ADDENDUM DESIGN STATEMENT

Change of Use to Upper Floors and Alterations
to create 46 Bedroom Hotel

1-3 York Street, Manchester

Fig 10: Part section detail with retained existing panelling highlighted in blue

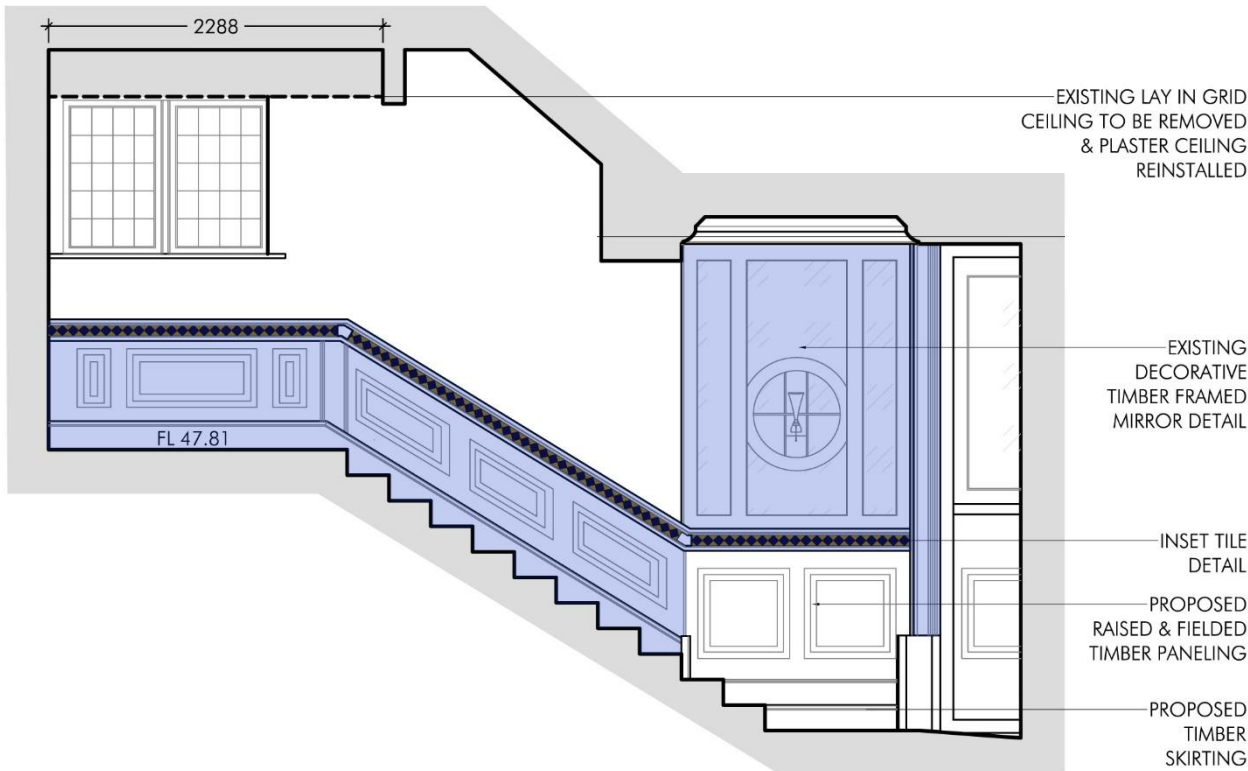
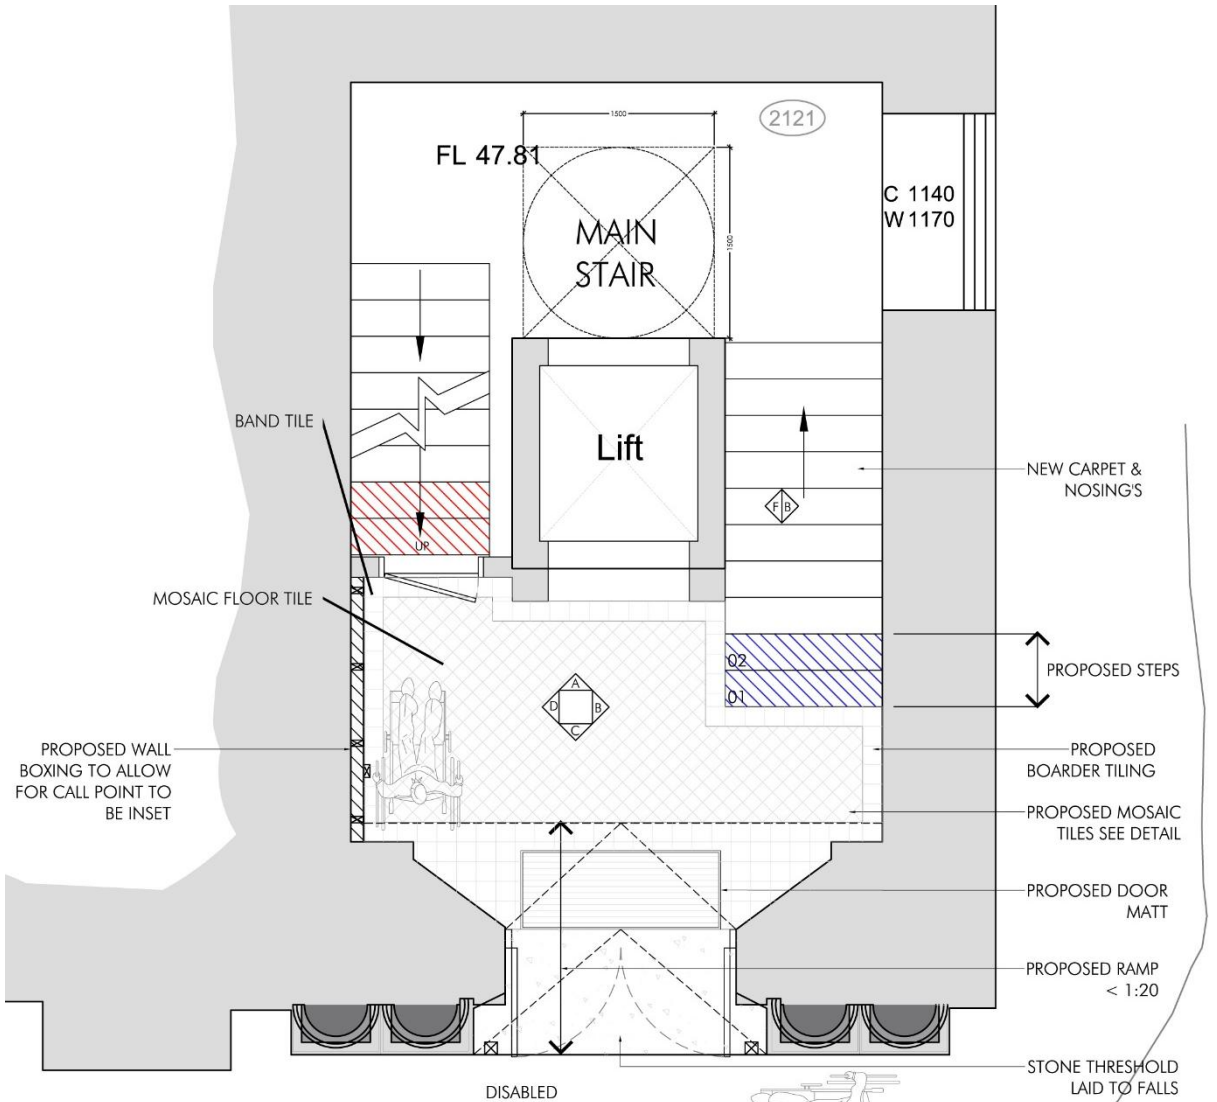
1.25	Entrance: Annotated plan to be provided detailing finishes in entrance. Final details to be conditioned. Annotated cross-section to that end required as part of the LBC, showing the design/appearance of the new panelling, step etc.	This has been provided – see drawings AP50/A and AP51/A	1.8

2.03	Confirm the impact of the proposed wall boxing – see proposed ground floor finishes as per drawing no. AP51	The wall is proposed to be boxed-out with studwork and the existing panelling re-fixed, this is to allow the proposed fire alarm panel and disabled call points to be fitted recessed into the wall rather than fitted over the panelling. A 1:10 detail of this proposal has been added to drawing AP51/A.	1.8 & Drawing ref: AP51/A

2.04	Amendments: - Tiled floors – reuse and retain pattern; - Retain panelling to elevation A - Remove wallpaper	Drawing AP51/A has been updated to show the re-use of the existing floor tiles. As stated in the Addendum Design Statement section 1.8, should they be bedded in cement/concrete removal may not be possible, in which case new floor tiles in similar patterning may be used. Drawing AP51/A has been updated to show the panel details on elevation A retained. Drawing AP51/A has been updated to show the existing wallpaper removed, plaster made good and painted.	1.8 & Drawing ref: AP51/A

Further details for the treatment of the entrance lobby, following the lowering of the structural floor for level access, has been provided on drawings AP.51 (internal) & AP.32 (external). Externally, plinth stonework shall be made good, the existing doors re-used and fitted with power assisted automation, and a new fan light added above it. Rather than fixing to the building, door activation and voice communication for nighttime use will be provided on free-standing stainless steel posts located within the recess of the external portico.

Internally, where the floor is to be structurally lowered, stair panelling and lobby panelling above dado height (including the decorative dado inlay) shall be retained and protected during the works. 1:10 scale details of the proposed new lower-level panelling have been provided on drawing AP.51. the existing modern wallpaper above dado level to the perimeter walls and around the lift shaft shall be removed and the plaster finish made good and painted.

The floor tiles, if bedded in a lime- or sand-based compound, shall be removed and cleaned for re-use. As the building dates from 1902 and incorporates a structural concrete floor, it is possible that the existing ceramic floor tiles will be bedded in a cement-based screed, making it impossible to take up the existing floor tiles for re-use. If this is the case, they shall be replaced with new Victorian-style fired matt ceramic mosaic and band tiles in a similar patterning/rationale to the existing flooring.

Fig 17: Room 307 – UPDATED PROPOSED CONSERVATION-LED APPROACH

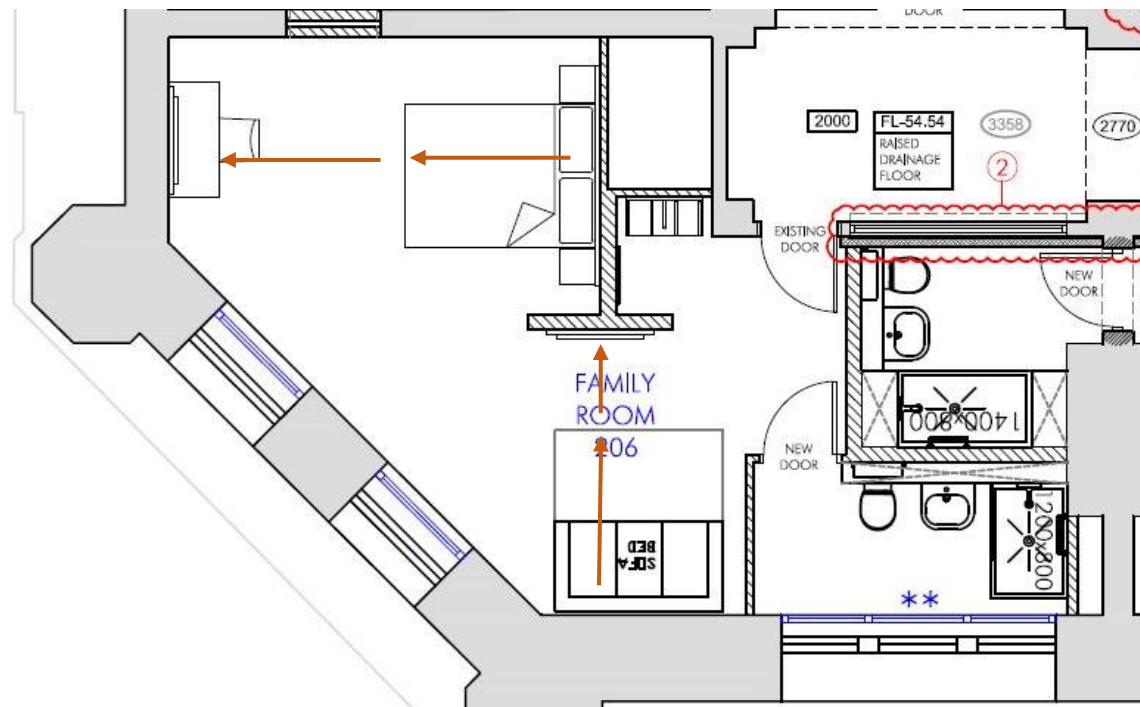
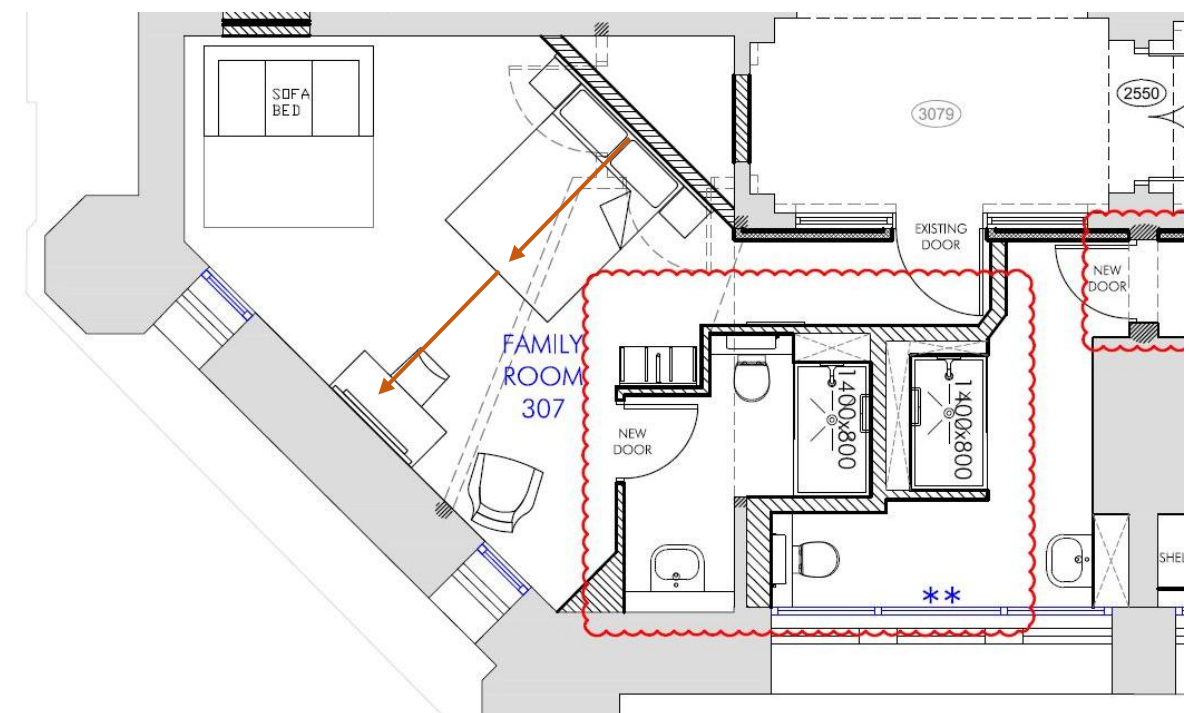
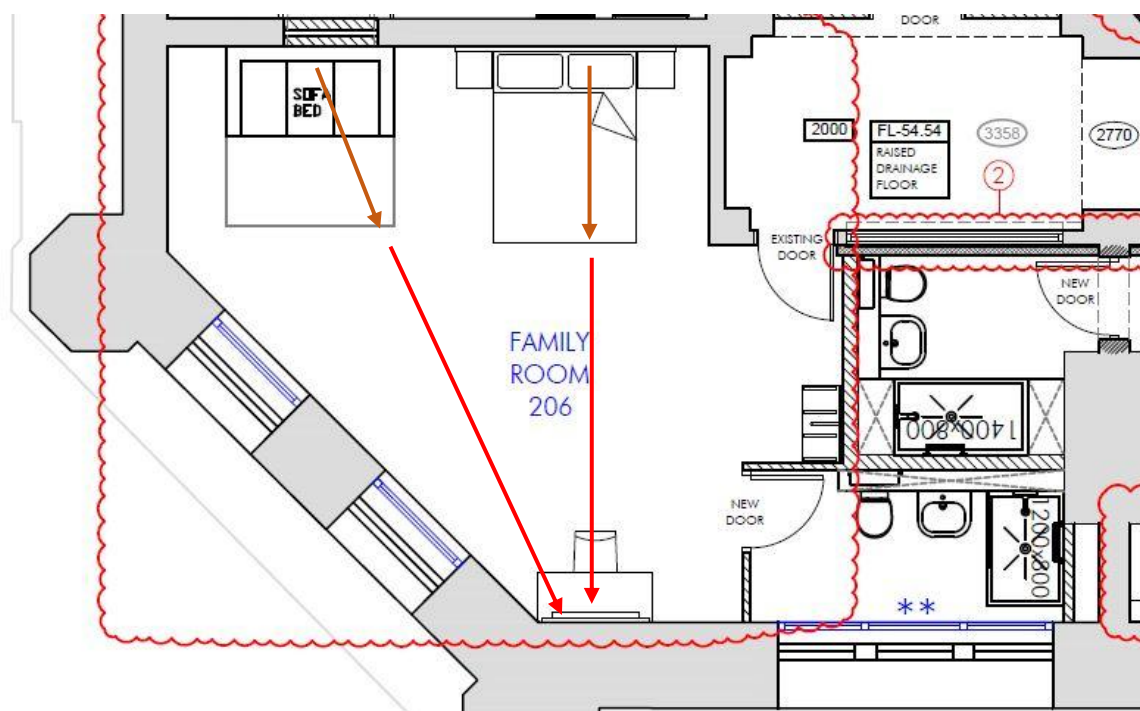
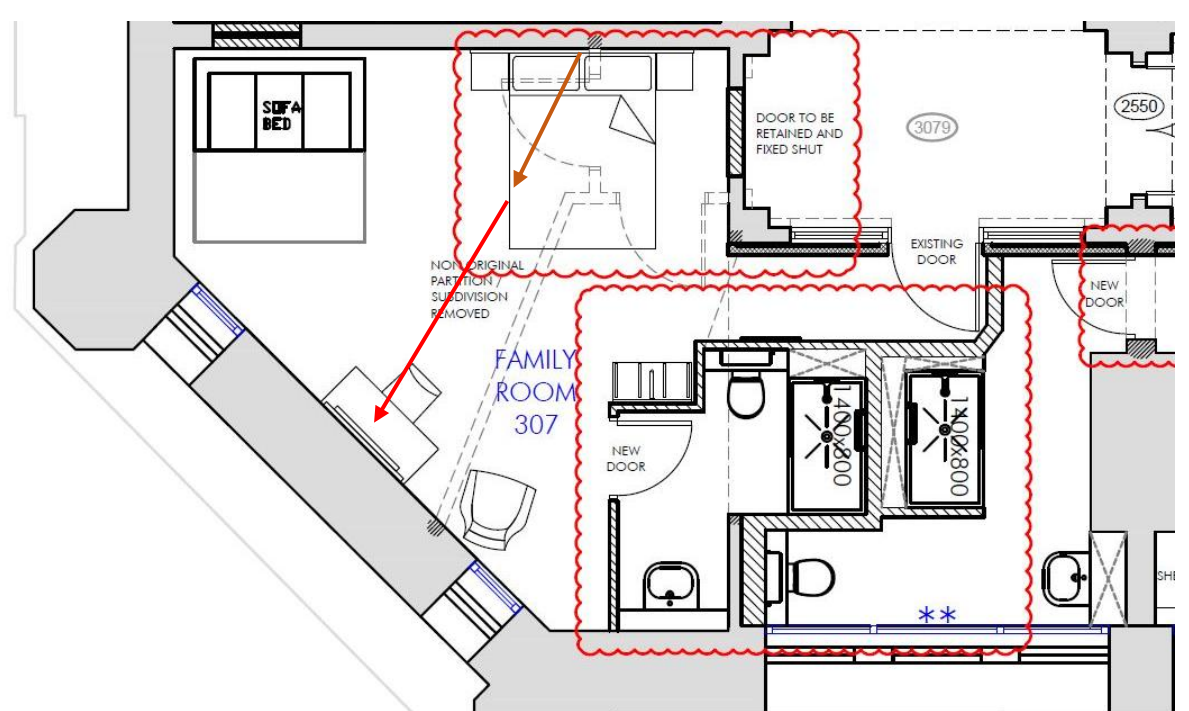
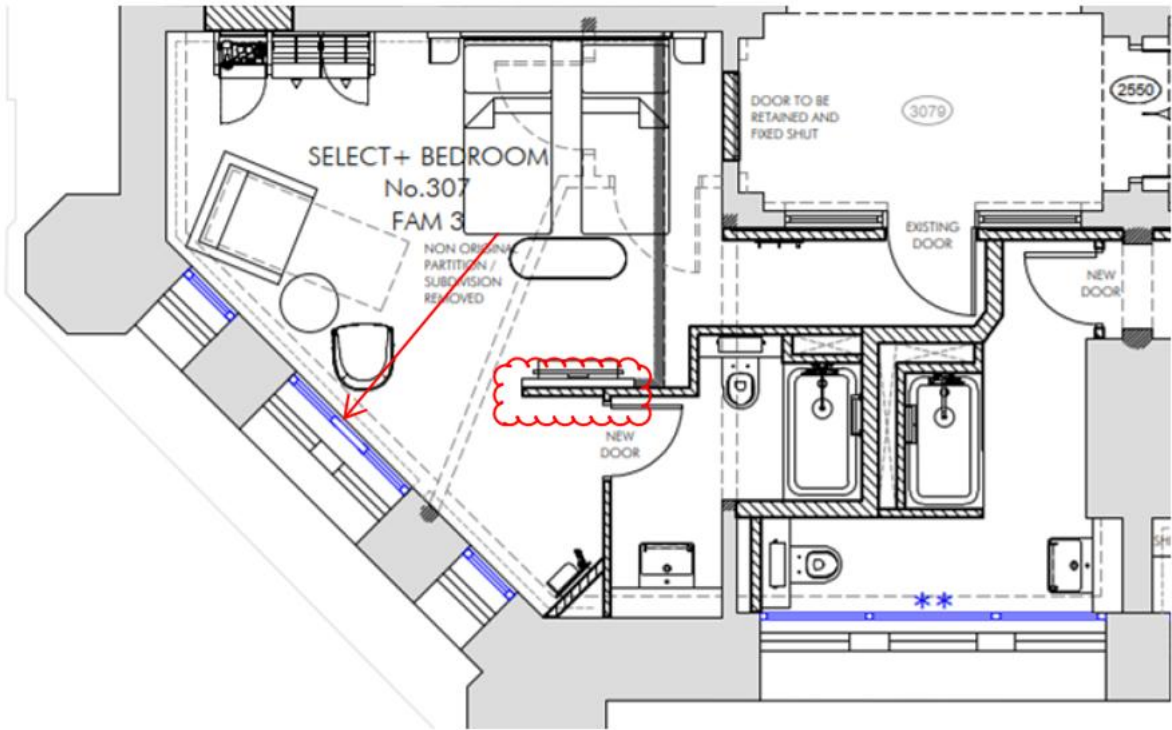
3.04	Remove proposed 'boarding-out' of the wall in the proposed family rooms 206 and 307	The rooms 206 & 307 were originally designed to optimise guest experience, they have now been altered to prioritise retaining the existing volume and cornicing to each room space. Revised drawings AP02/J & AP03/H Also note in mitigation that room 307 includes the removal of non-original partition walls that already subdivided that space.	1.10 Drawing refs: AP02/J; AP03/H

Rooms 206 & 307 are large 'family' rooms formed in a larger corner volume. The Conservation Officer has requested that we "Remove the proposed 'boarding-out' of the wall in the proposed family rooms 206 and 307". Here we compare the previous proposal with the new, to show we have prioritised the heritage preference to retain as much original uninterrupted volume of the spaces as possible. In room 307 a previous subdivision partition wall has been removed to recreate this volume.

The previous designs were 'hotel'-focused – e.g., having a TV directly facing the beds and no more than a further bed-length away from the bedhead for ease of viewing. Instead, we have now taken a heritage-led approach to restore the room volume and compromise on the room amenity.

A small section of new wall has been added to Room 307 to provide an area for a TV to be displayed. We believe that this small section of new partition doesn't detract from the original room volume.
